ADDENDUM No. THREE

Date: September 19, 2025
Project: Jones Street Reclamation, MES No. 2025-06
Engineer: M.E. Sack Engineering *MS*
Hinesville, Georgia

C200

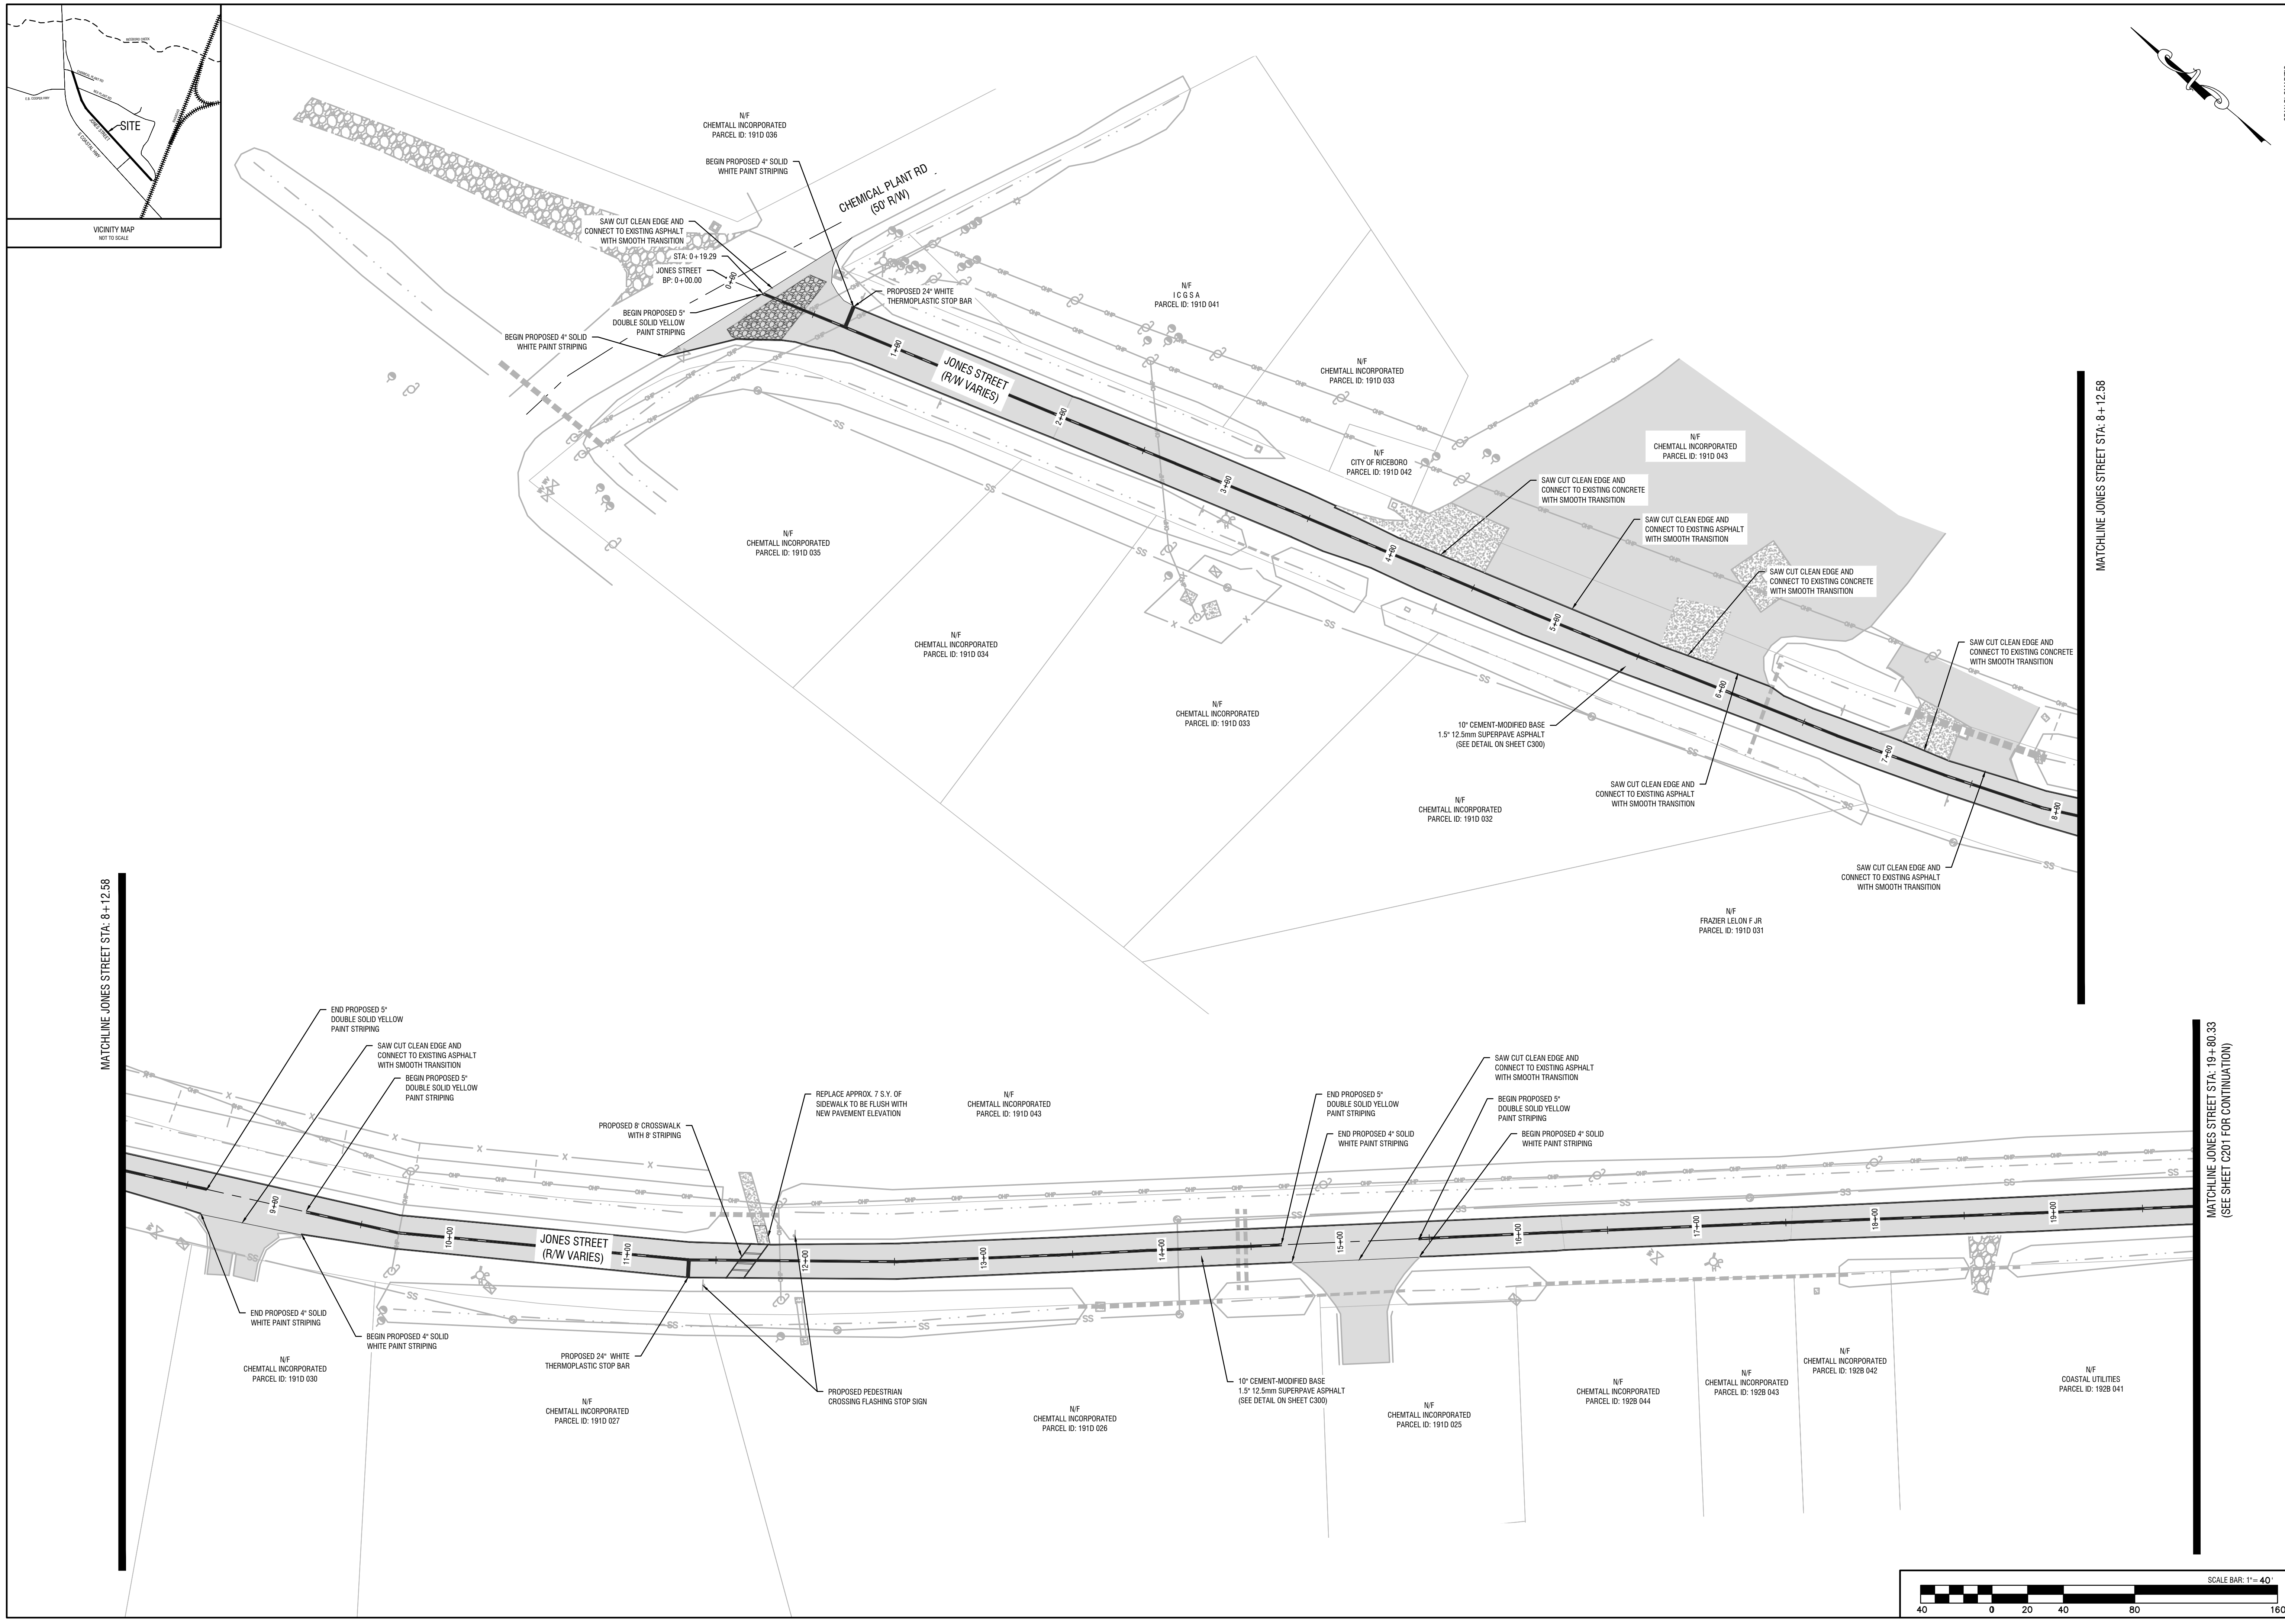
- Replace the previous Sheets C200-C201 with the enclosed of the same. Note that revisions were made to remove dimension labels and match edge of pavement lines to existing.

- 1) *I noticed on site today that the gates on Jones Street are 20 feet apart from post to post. The new roadway is proposed to be 24 feet wide. Will these gates be removed before construction or will we need to remove and reset these?*

- 2) *Also, there is over 1,000/Sy more of proposed paving than there is existing due to the new proposed width. Is it the intention to mix the existing material outside the existing pavement or will removal/widening be required. If so, please clarify the method required.*

- The proposed pavement and base have been updated to match the existing road widths, instead of the proposed 24 foot width. The gates will need to be removed to perform the work and replaced afterwards; therefore, a new "Structure Remove/Replace" bid item has been added.

- The quantities of asphalt paving have been updated to match the area of the full depth roadway reclamation. Therefore, the existing material can be mixed and reused without any extra removal or widening required.
